DOUBLE BRIDGES ROAD PATHWAY, MUDDY NECK TO NEPTUNE DRIVE

CONTRACT NUMBER: T201769009
FEDERAL AID PROJECT NUMBER: CMAQ-2020(38)
COUNTY: SUSSEX M.R. #: S363

ADDENDUM 2
October 1, 2026

THIS SEAL APPLIES TO THE FOLLOWING SHEETS
CHANGED UNDER ADDENDUM #2:
1, 3, 23, 24, 28, 29, 31, 60

PIER CAP CONNECTION DETAIL
SCALE : 1" = 1'-0"

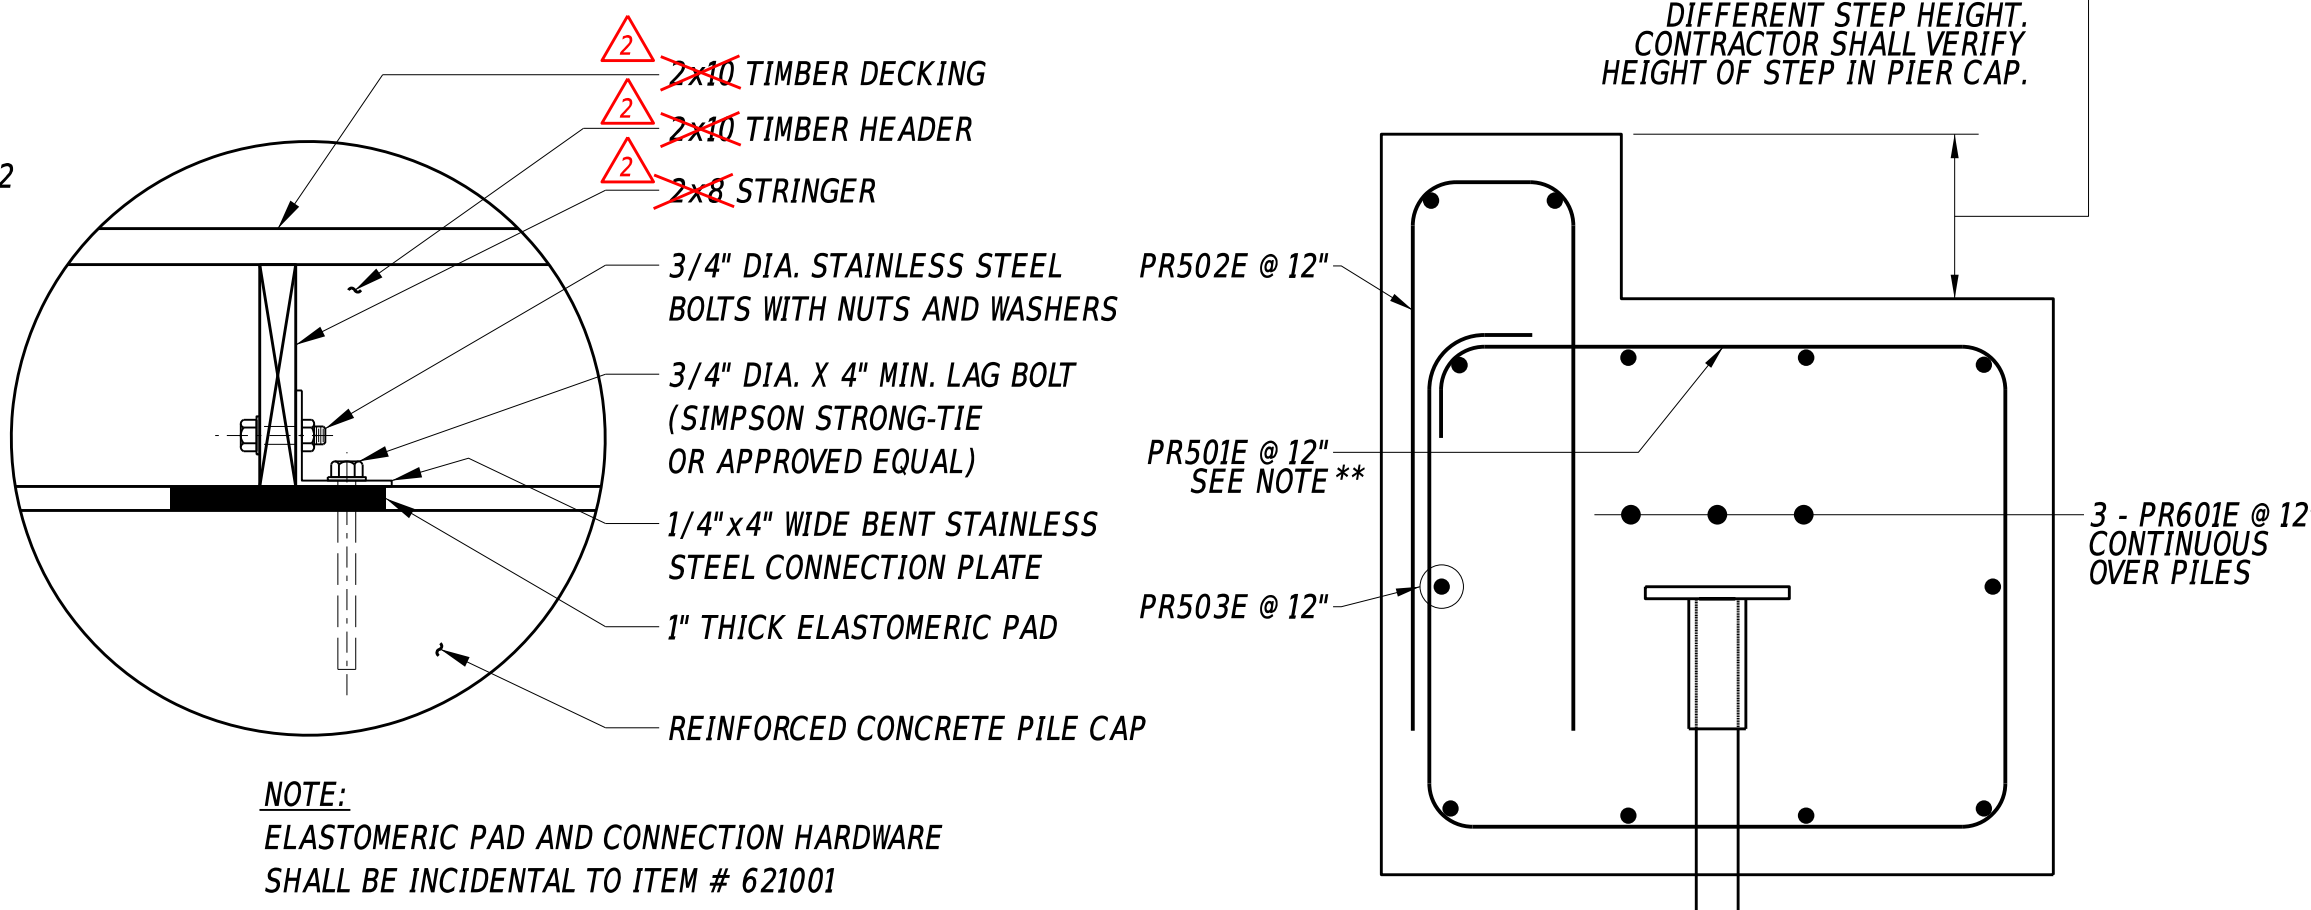
ADDED ELASTOMERIC BEARING NOTES, REVISED PIER CAP CONNECTION DETAIL CALLOUTS, AND ADDED PILE LOADING. BMC 9/28/26

- ELASTOMERIC BEARING NOTES:**
- 20 TOTAL ELASTOMERIC BEARINGS REQUIRED.
 - ALL ELASTOMERIC BEARINGS SHALL BE 50 MIN. DUROMETER IN ACCORDANCE WITH REQUIREMENTS SPECIFIED IN SECTION 623 OF THE STANDARD SPECIFICATIONS.
 - ELASTOMERIC BEARINGS SHALL BE ATTACHED TO THE TOP OF PIER CAP WITH AN APPROVED EPOXY ADHESIVE IN ACCORDANCE WITH SECTION 623.3.D.4 OF THE STANDARD SPECIFICATIONS IN SUCH A WAY THAT VISIBLE CONCRETE SURFACES WILL NOT BE STAINED. ENSURE THE EPOXY ADHESIVE HAS SET PRIOR TO PLACEMENT OF STRINGERS.

DOUBLE BRIDGES ROAD PATHWAY, MUDDY NECK TO NEPTUNE DRIVE	CONTRACT	BRIDGE NO.	3-455P	BOARDWALK APPROACH SECTION AND DETAILS	SECTION
	T201769009	DESIGNED BY:	B. CURTIS		CEN
	COUNTY	CHECKED BY:	C. PERCY		SHEET NO.
	SUSSEX				31

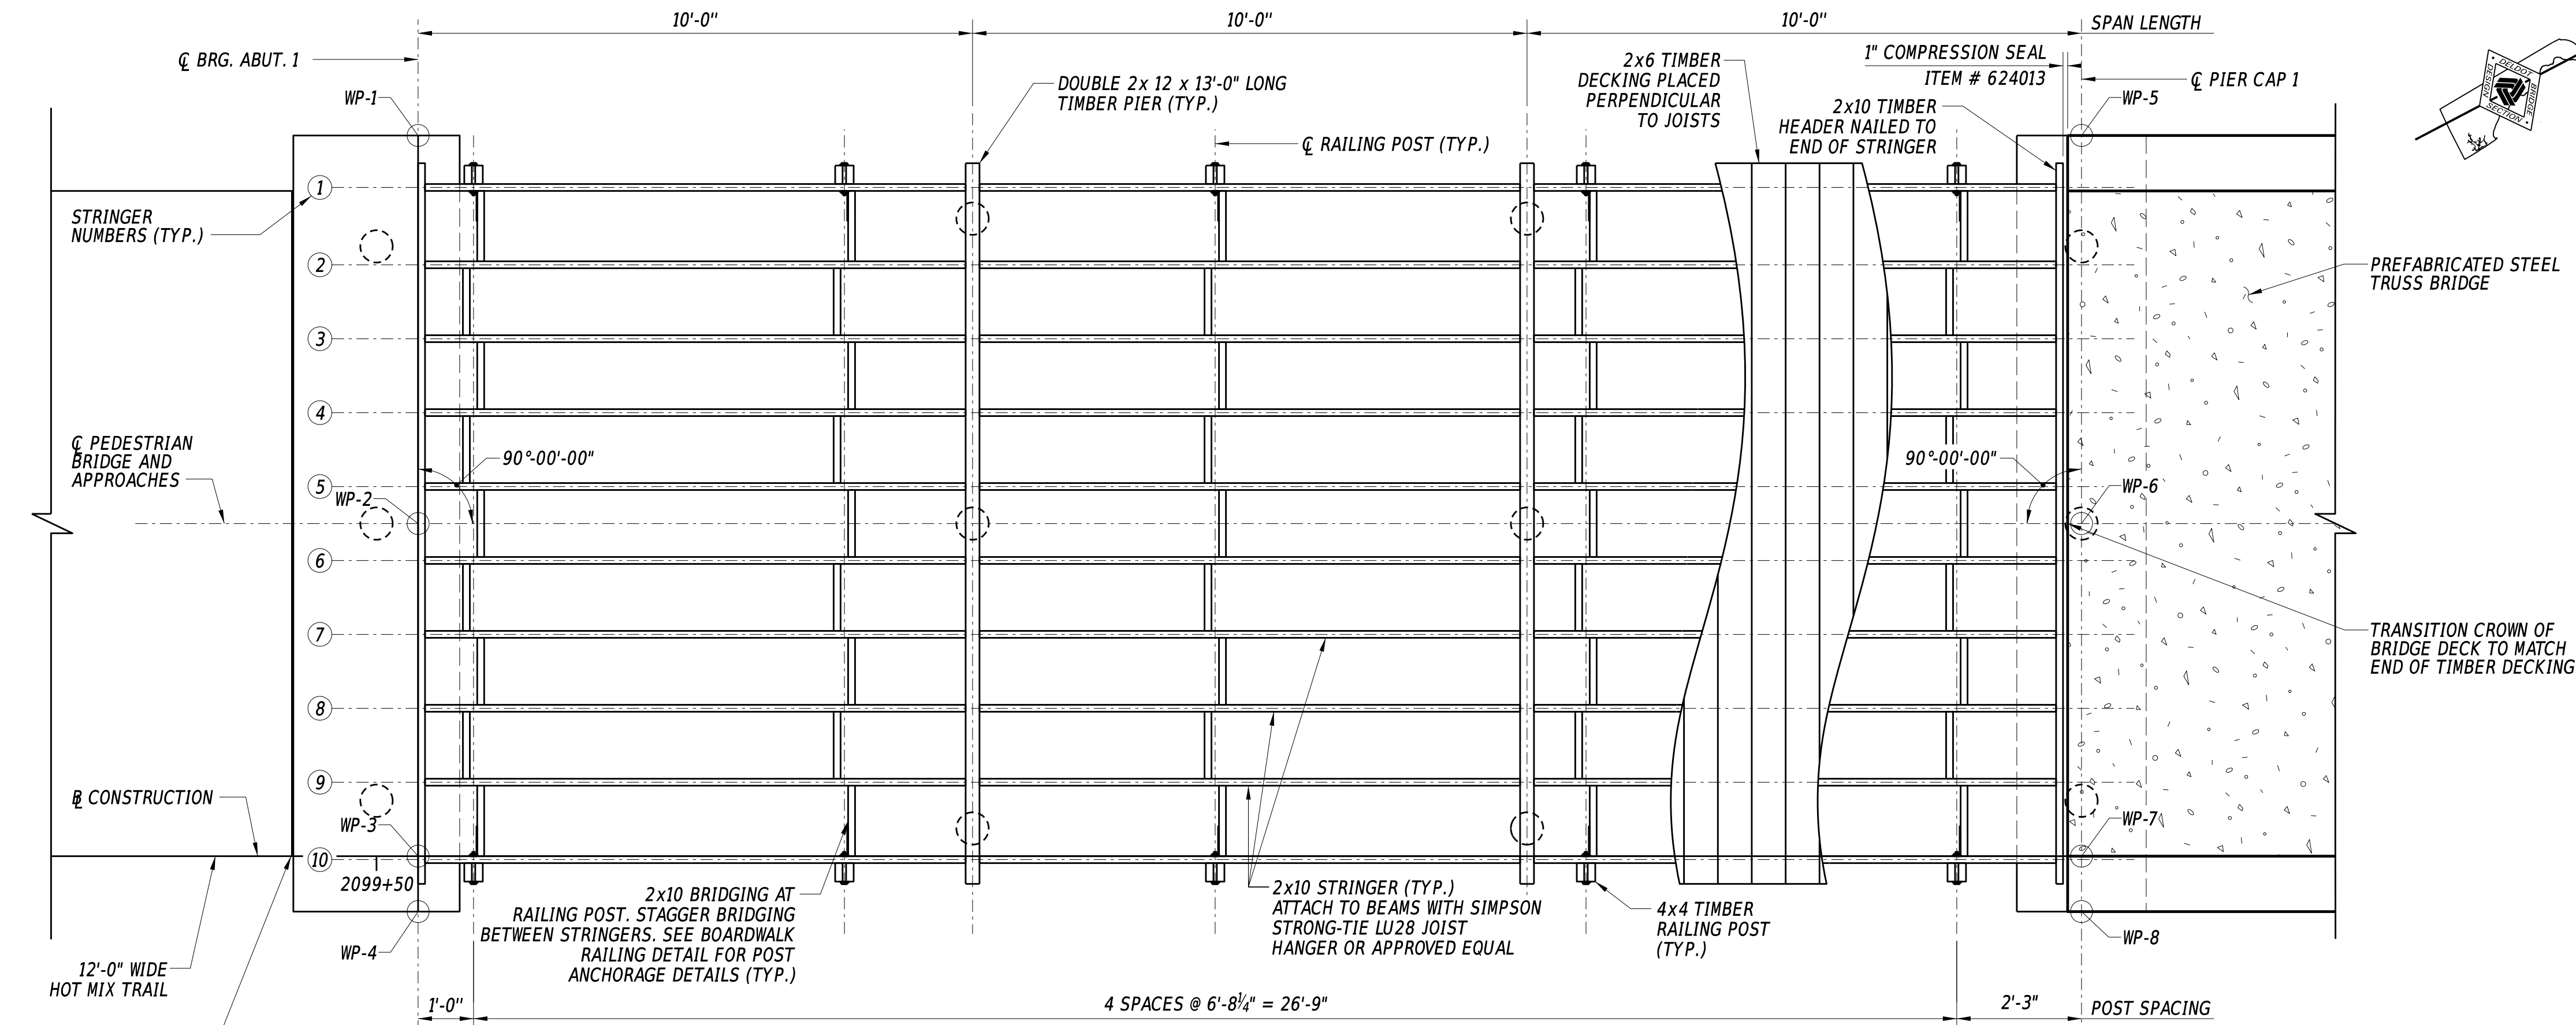
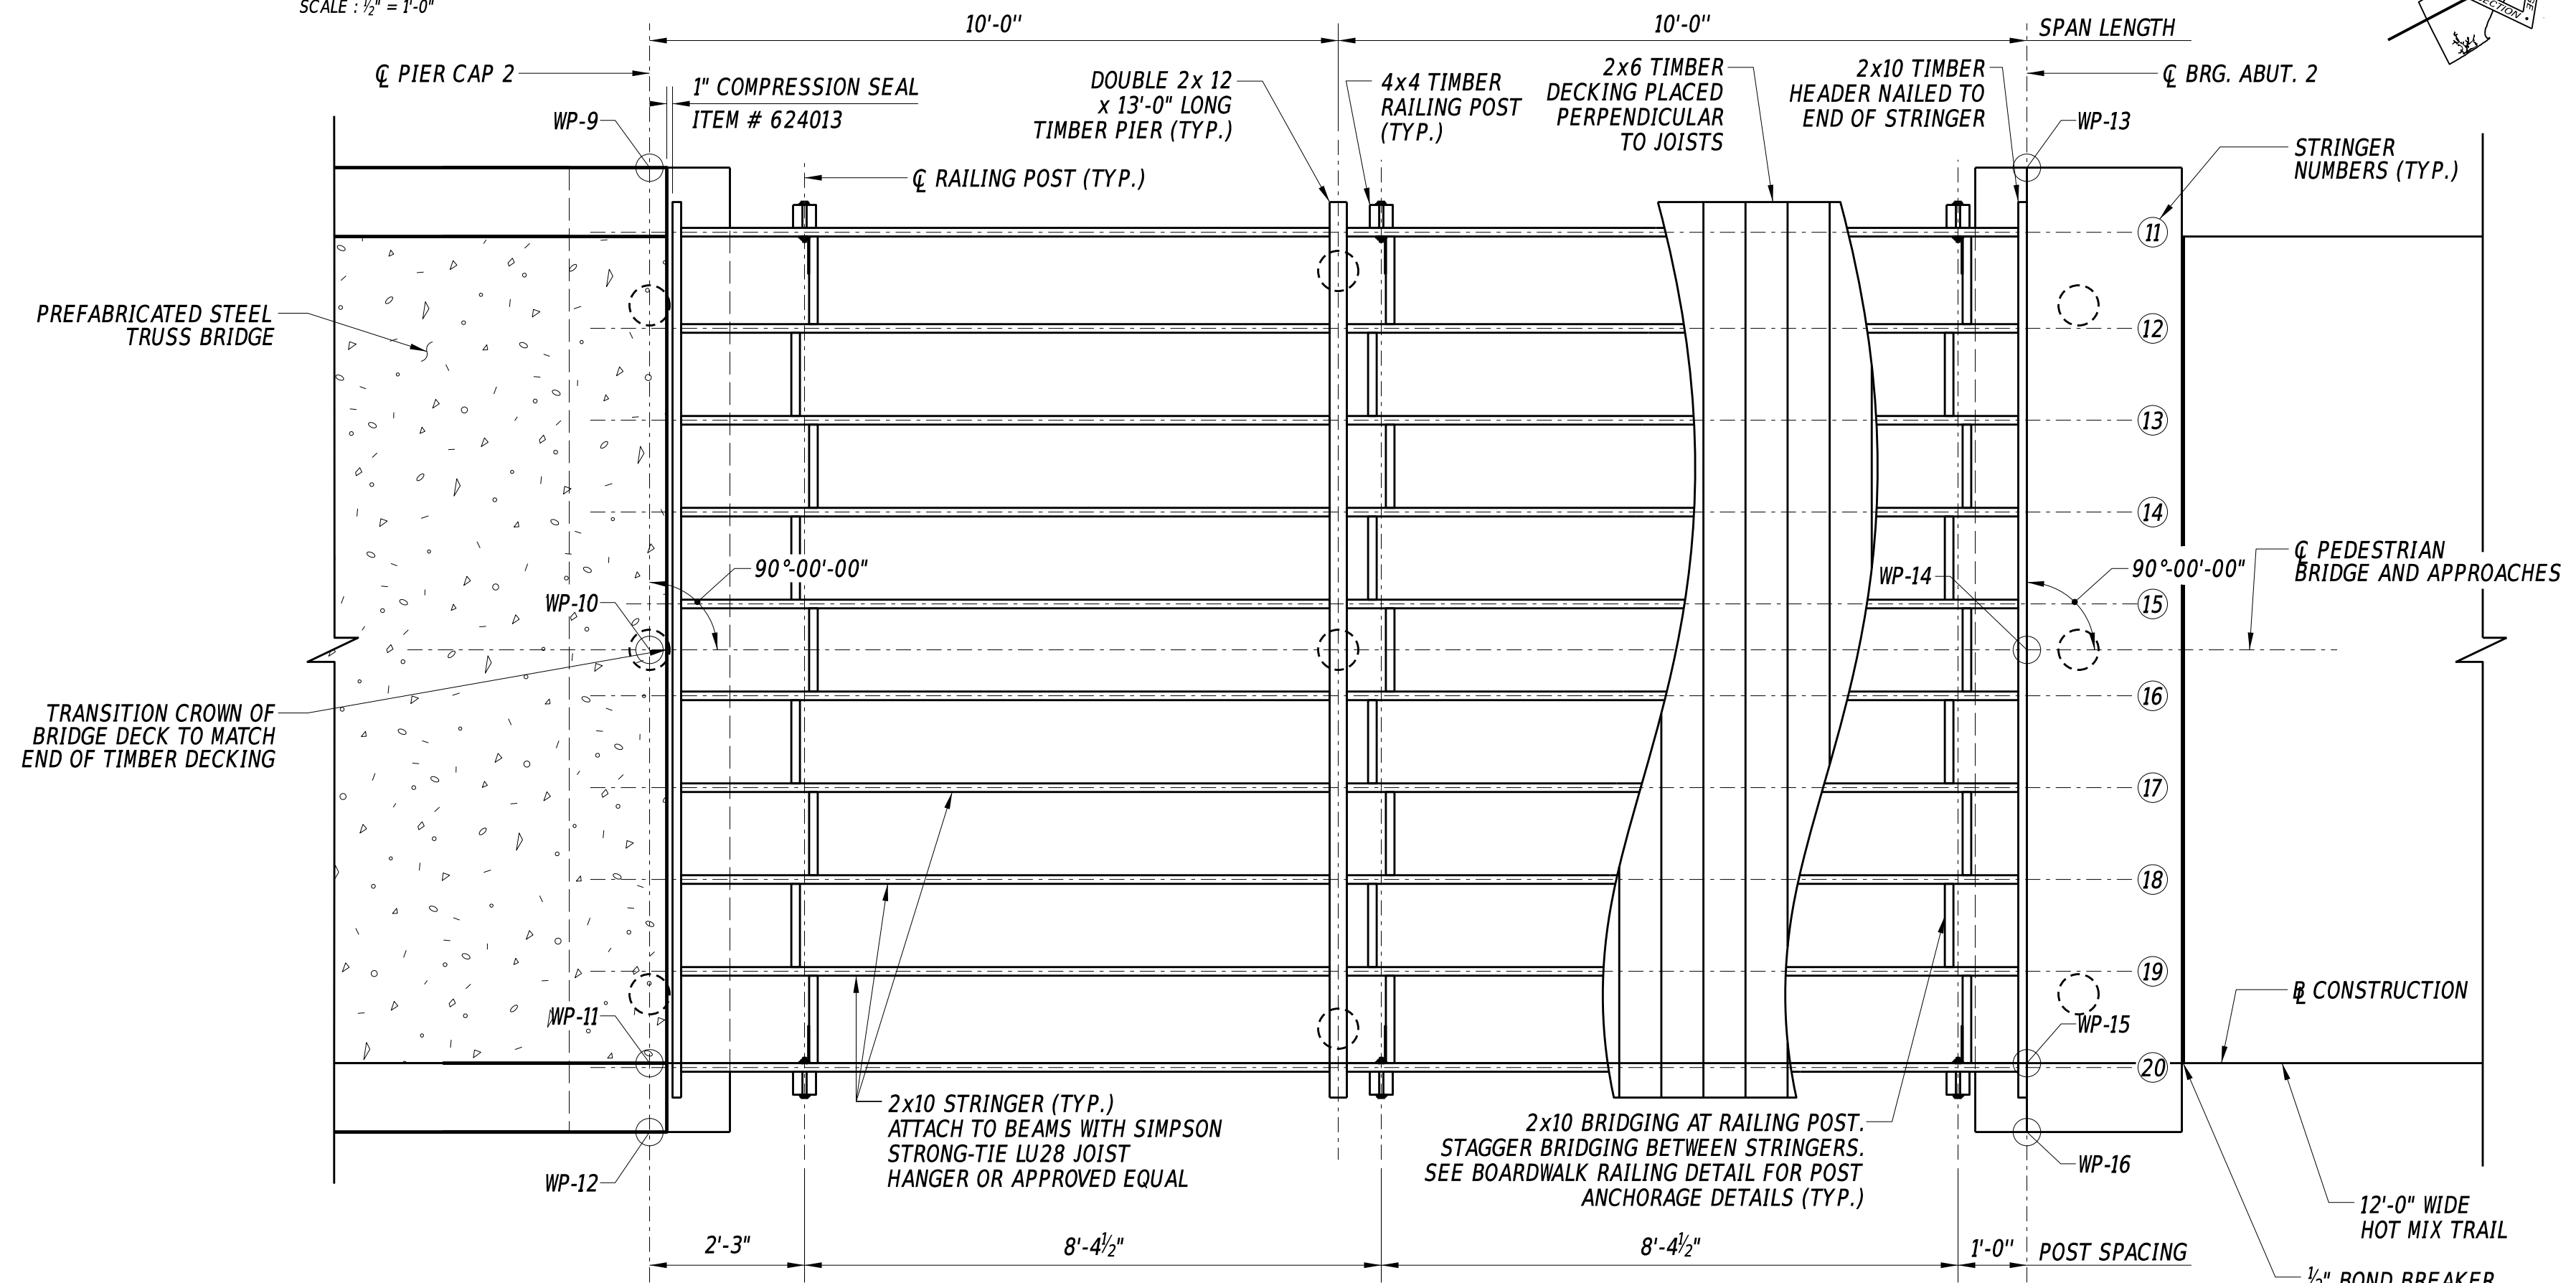
ADDENDA / REVISIONS	
△ ADDED PILE LOADING. BMC 9/28/26
